Norwood Young America Planning Commission
Tuesday, February 6, 2018
Norwood Young America City Council Chambers, 310 Elm St. W.
6:00 p.m.

To: Chairperson Heher
Members of the Planning Commission
Administrator Helget

To: Chairperson Heher
Members of the Planning Commission
Administrator Helget

RE: 2018 Vickerman Company Warehouse Expansion
Site Plan Review
Tacoma West Industrial Park 3rd Addition
Project No.: C14115308

**TACOMA WEST INDUSTRIAL PARK
3RD ADDITION**

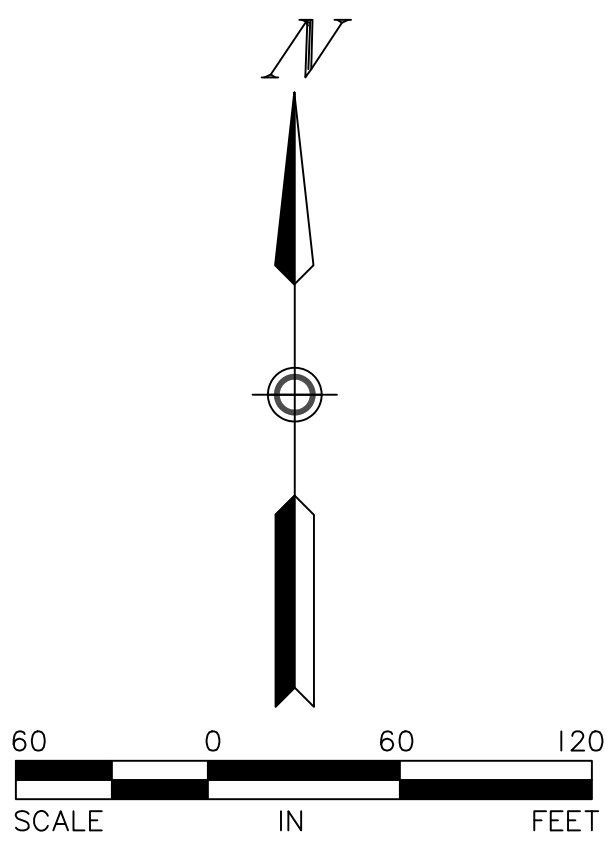
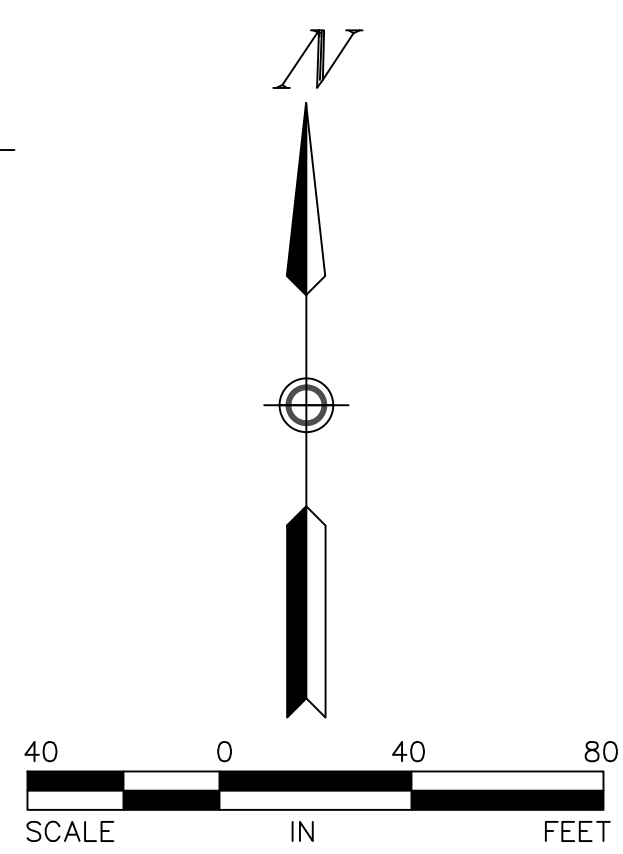
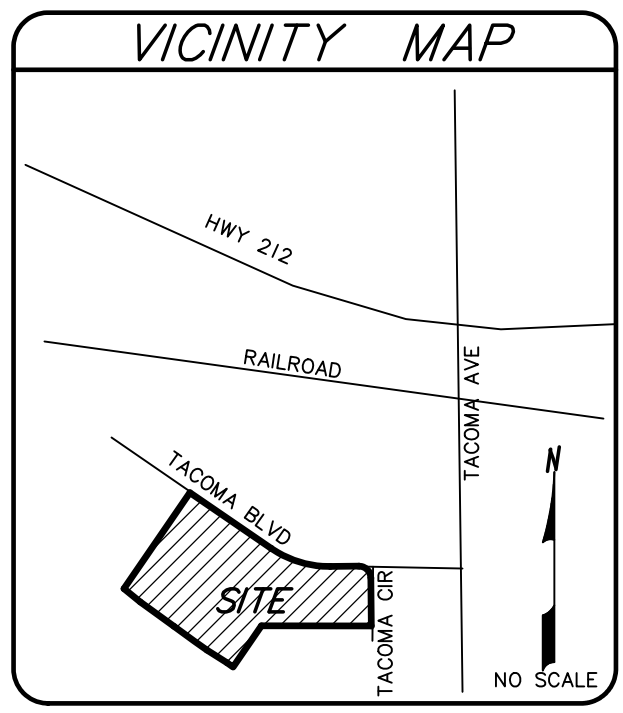
Staff recommends approval of the preliminary and final plat contingent on the following:

1. Title review by the City Attorney.
2. Incorporation of comments contained in a staff memo dated January 25, 2018 from John Swanson, Bolton-Menk.
3. Incorporation of comments from Carver County Surveyor's Office and Taxation, if applicable.
4. Certification that all taxes are paid.
5. Recording of the final plat at the Carver County Recorder's Office within 120 days of the date of approval by the City Council.

1 NORTH ELEVATION
Scale : 1" = 20'-0"

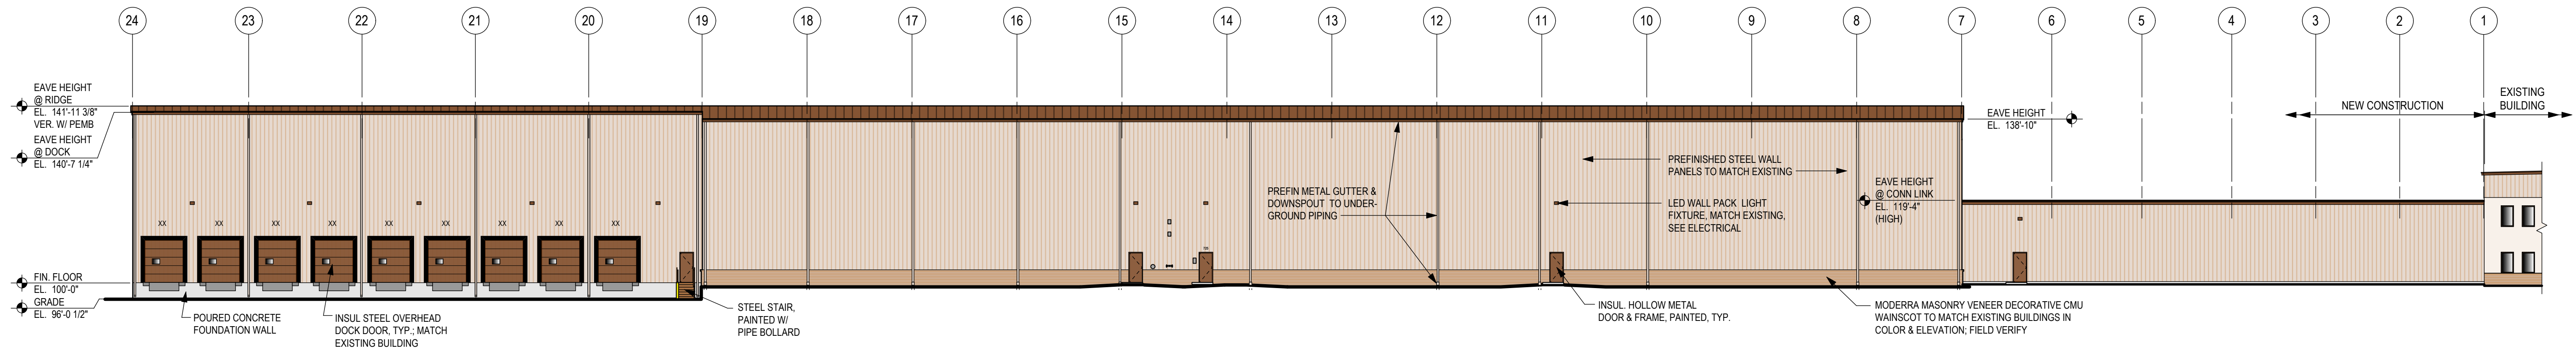
1. As depicted in the elevation rendering, the Applicant proposes a building height of 42 feet. The maximum height allowed under Section 1230.12, Subd. 5(D) is 40 feet.
2. The Applicant proposes a zero interior yard setback to accommodate a ground-level link to an existing structure on an adjacent lot. The minimum interior side yard setback prescribed under Section 1230.12, Subd. 5(E) is 15 feet.
3. The Applicant proposes a reduction of the number of tree plantings required under Section 1255.04(A) of the City Code. As illustrated on the associated landscape plan, the Applicant proposes installation of foundation plantings and ten (10) trees; the Code requires tree planting at a rate of one tree per 1,000 gross building area, or in this case planting of 119 trees.

1. The "Use" of the property is an 118,698 square foot warehouse facility on a single parcel of record.
2. Variance approval is contingent on approval of a site plan.
3. The maximum building height is 42 feet.
4. The zero foot setback is applicable only to a 32-foot at-grade "link" between an existing building and the proposed structure.
5. The Applicant shall install foundation plantings and a minimum of ten (10) overstory trees on the subject parcel pursuant to a landscape plan to be submitted and review administratively.
6. The variances shall expire one year after date of approval unless the Applicant has commenced construction of the principal structure.
